PROJECT NAME:
 3993-4021
 SHALLOWFORD
 SUBDIVISION
 OWNER OR CLIENT:
 RICHARD DUNN

SCALE: 1" = 40' (FULL SCALE)
 FULL SCALE 1" = 40'
 DRAWING TITLE:
 ZONING PLAN

PETITION NO: Z-35

ZONING COMMENTS:

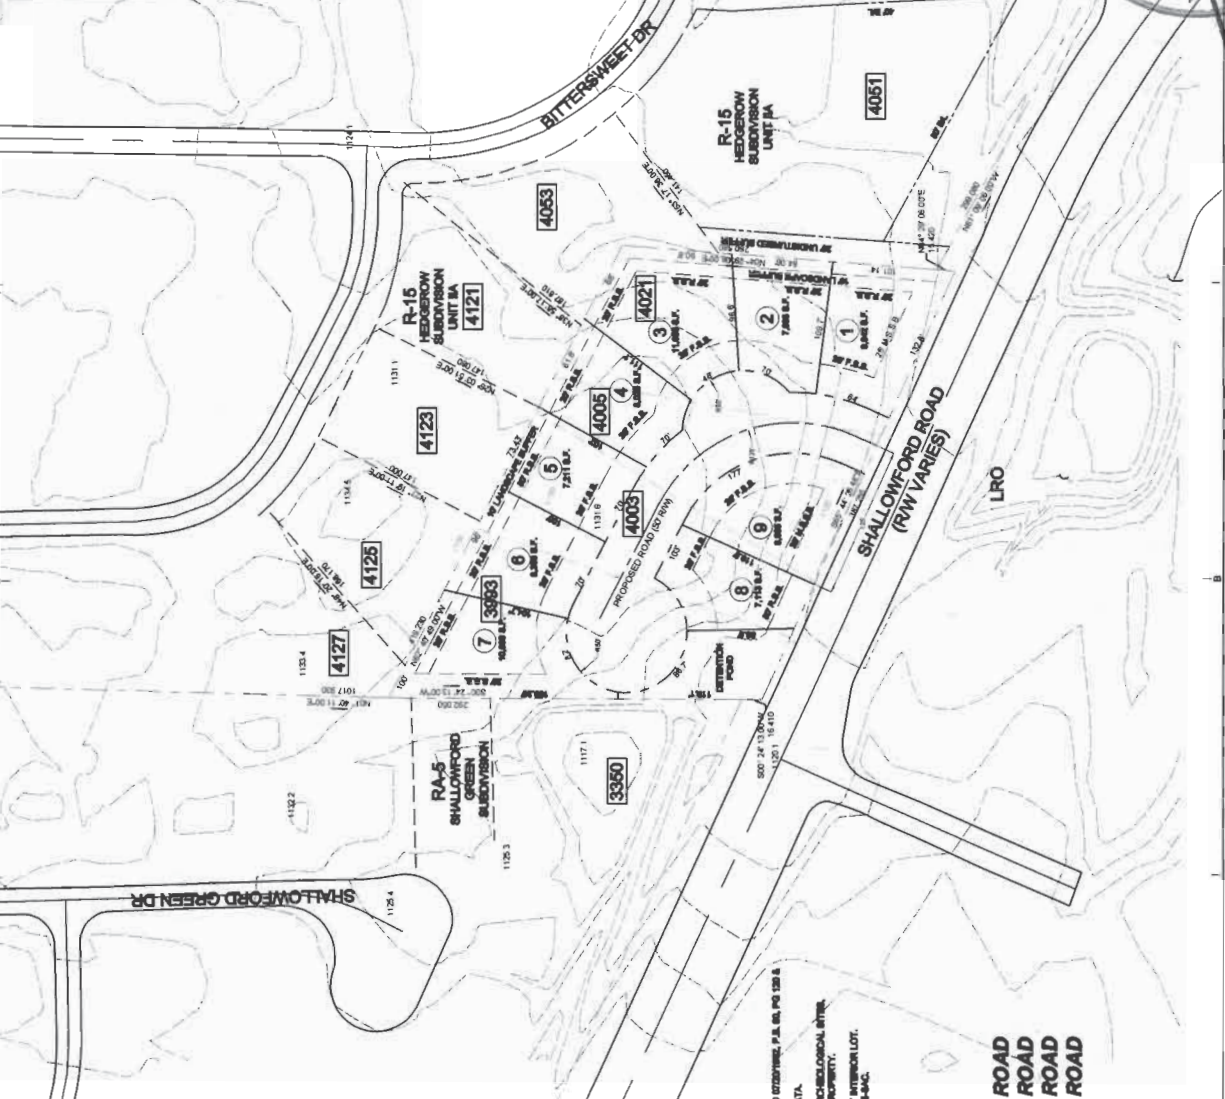
- No Stormwater controls shown _____
- Copy of survey is not current – Additional comments may be forthcoming when current site conditions are exposed.
- No site improvements showing on exhibit.

1. This site is located just north of Shallowford Road and is bounded on the north and east by Hedgerow Subdivision and on the west by Shallowford Green Subdivision. Slopes on the site are relatively mild ranging from 2 to 10%. The majority of the site (2/3) drains to the Shallowford Road R/W. The remaining third drains to the east into the Hedgerow Subdivision Recreation Area.
2. Any bypass runoff from the rear of lots 1 through 7 must be directed to the Shallowford Road right-of-way and not to the Hedgerow Rec Area.

Shallowford Road is classified as an arterial and according to the available information the existing right-of-way does not meet the minimum requirements for this classification.

Recommend applicant consider entering into a development agreement pursuant of O.C.G.A. 36-71-13 for dedication of the following system improvements to mitigate traffic concerns: a) donation of right-of-way on the north side of Shallowford Road, a minimum of 50' from the roadway centerline.

Recommend curb and gutter along both sides and sidewalk along one side of proposed development roadway.

Recommend a deceleration lane on Shallowford Road for the entrance.

Recommend removing and closing driveway aprons along Shallowford Road frontage that development renders unnecessary.

- Site plan received by Zoning Division on May 2, 2013 with District Commissioner approving minor modifications;
- Fire Department comments and recommendations;
- Cobb County Marietta Water Authority comments and recommendations;
- Water and Sewer Division comments and recommendations;
- Stormwater Management Division comments and recommendations;
- Department of Transportation comments and recommendations; and
- Owner/developer to enter into a Development Agreement pursuant to O.C.G.A. §36-71-13 for dedication of system improvements to mitigate traffic concerns.
